TECHNICAL NOTE

HUYTON TRADE PARK

RESPONSE TO KMBC

Client/Project owner	Derwent Development Management Limited
Project	Huyton Trade Park
Title of Document	Response to KMBC
Type of Document	Technical Note
Date	22/02/2023
Reference number	GB01T20E53.2PROJ.11020624
Number of pages	8

Client	DERWENT ESTATES		
Project	HUYTON INDUSTRIAL ESTATE LIVERPOOL		
Title	SWEEP PATH ANALYSIS OPTION 2 SHEET 4 OF 5		
Drawn	MB	Checked	JB
Original dtp. size	A3	Date	20.02.23
Scale	NTS	Approved	TD
Drawing Status	INFORMATION		Rev.
Drawing Number	20E53-SK-SPA-14		P01

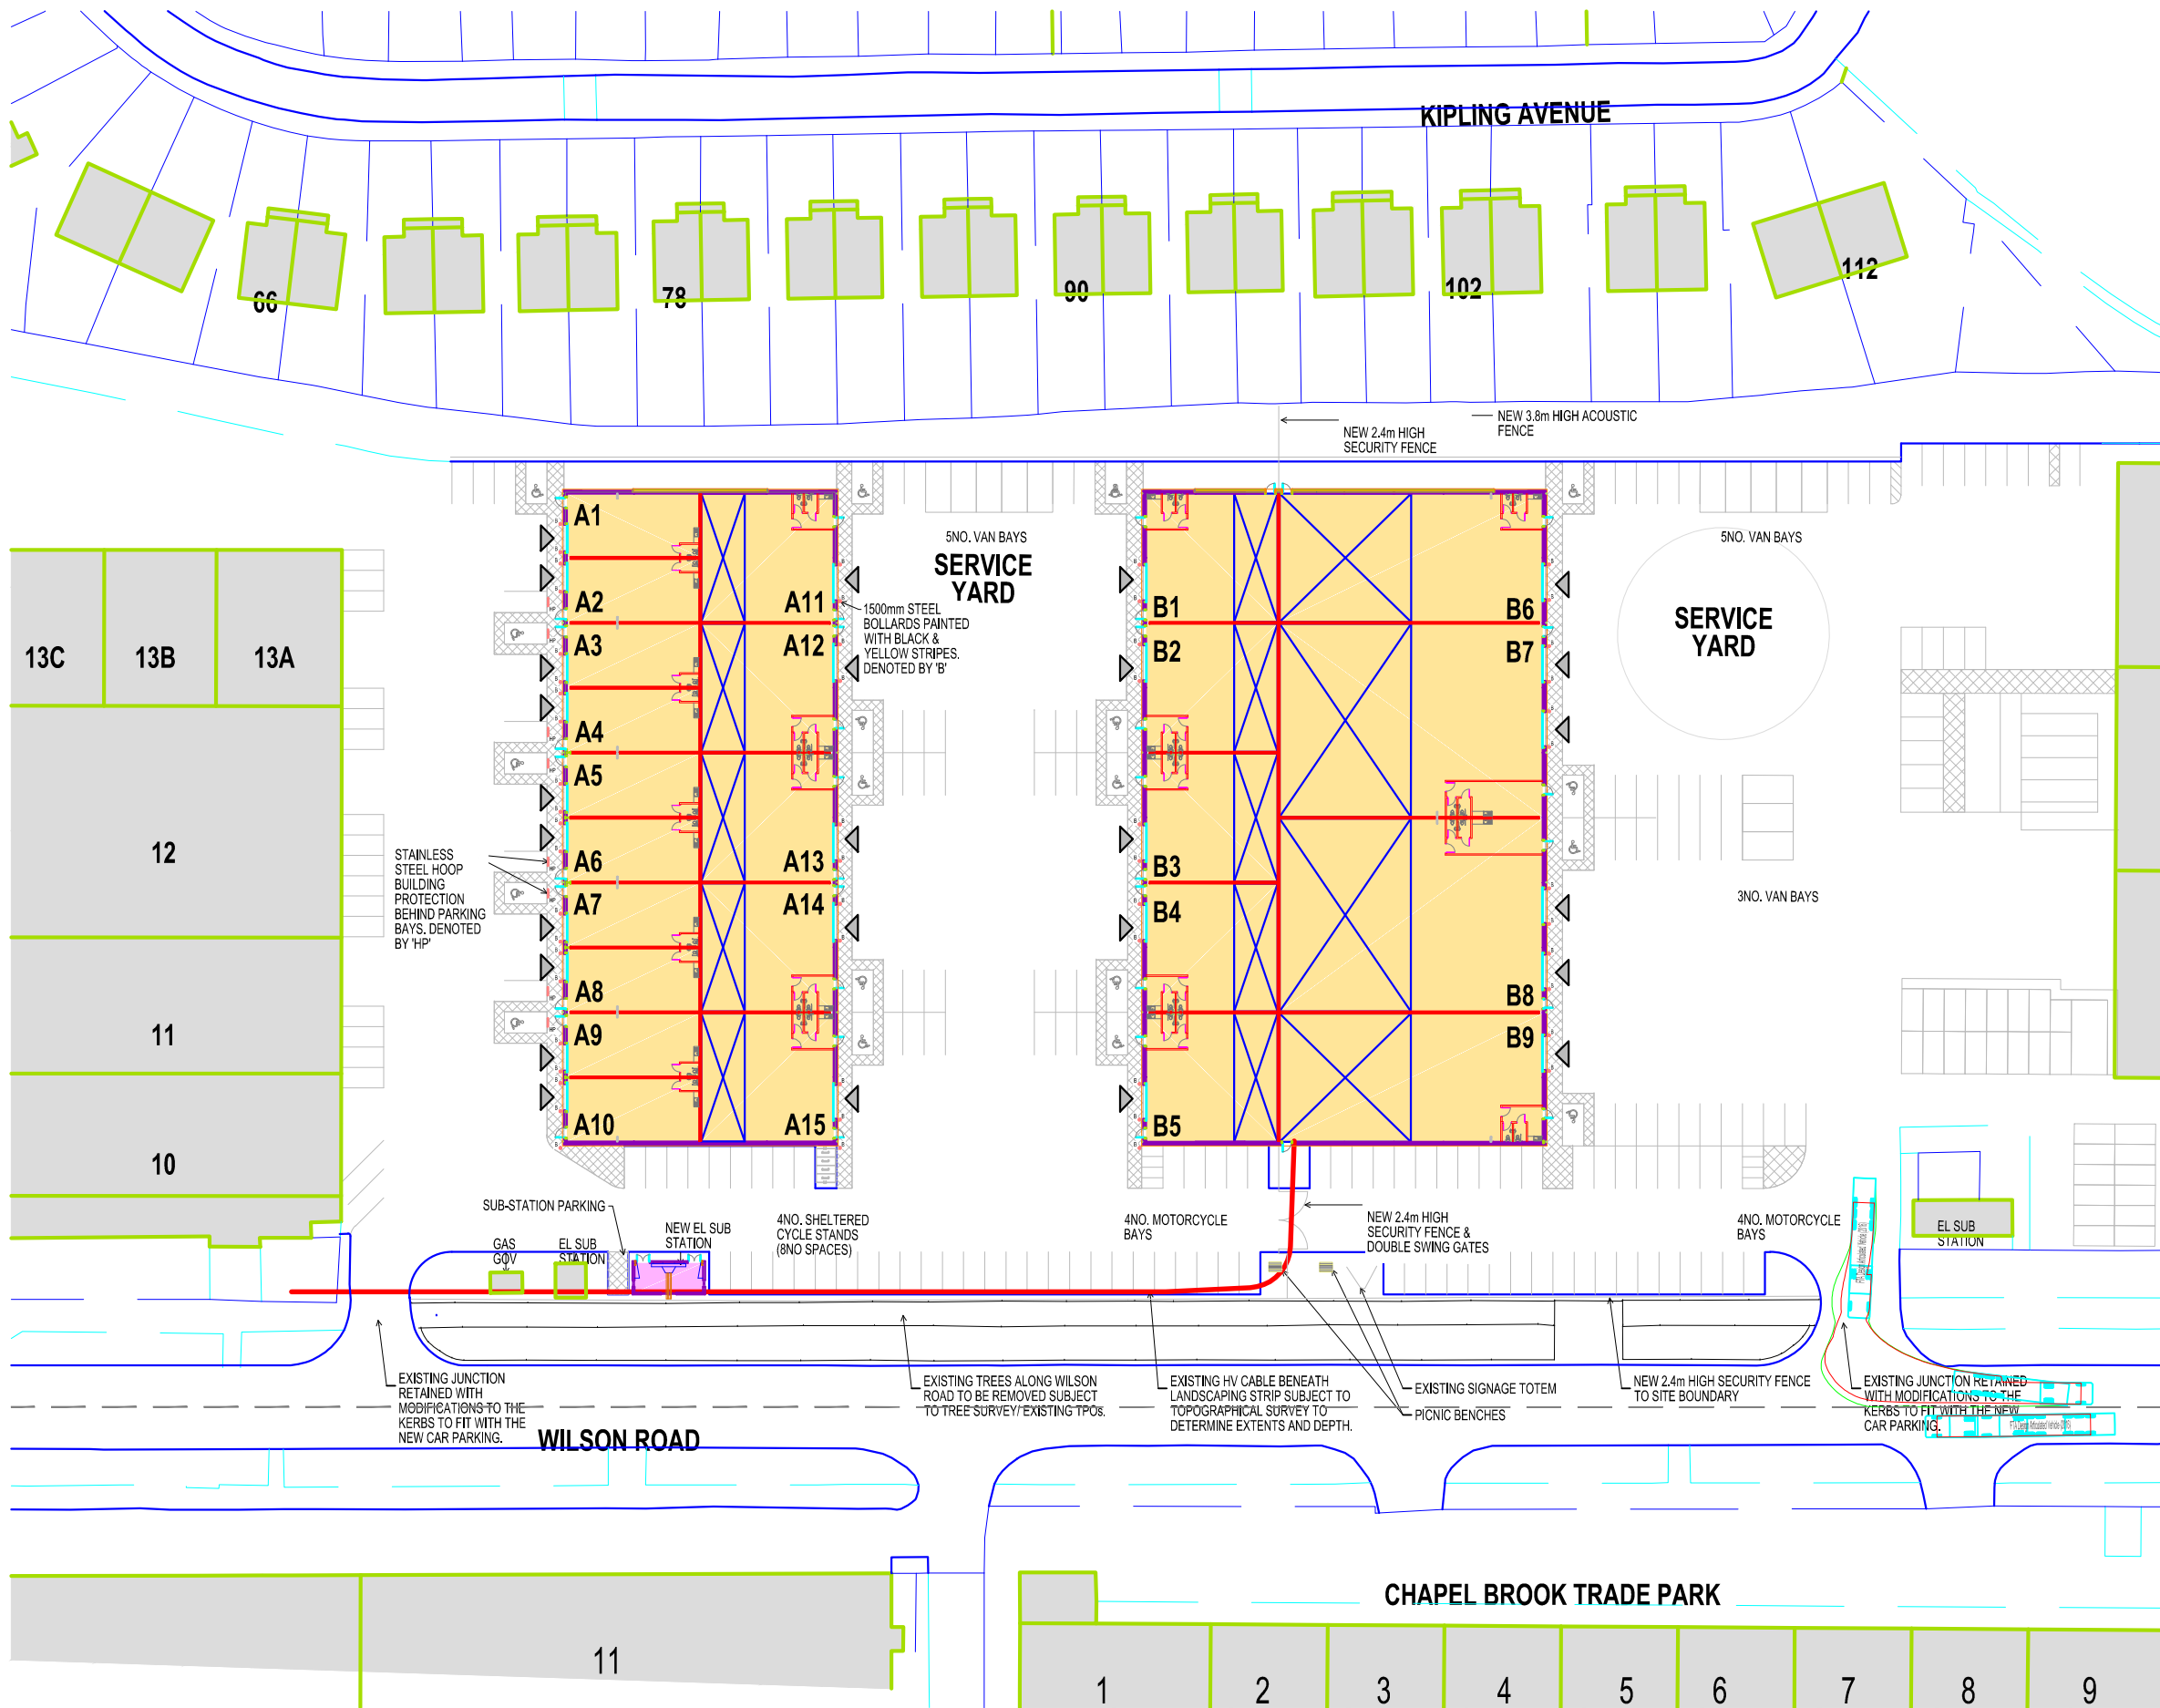
Existing swept paths show some vehicles to be occupying the right-hand lane which is deemed unacceptable by KMBC. Any swept paths showing the incorrect side of the carriageway being utilised will not be accepted.

- 2.1.4 The additional swept path analysis shows a maximum legal HGV exiting the application site and routing to the west [Drawing no. 20E53-SK-SPA-14] via Wilson Road. As shown, HGV drivers are able to undertake this manoeuvre without crossing the centre line of Wilson Road [Figure 3].
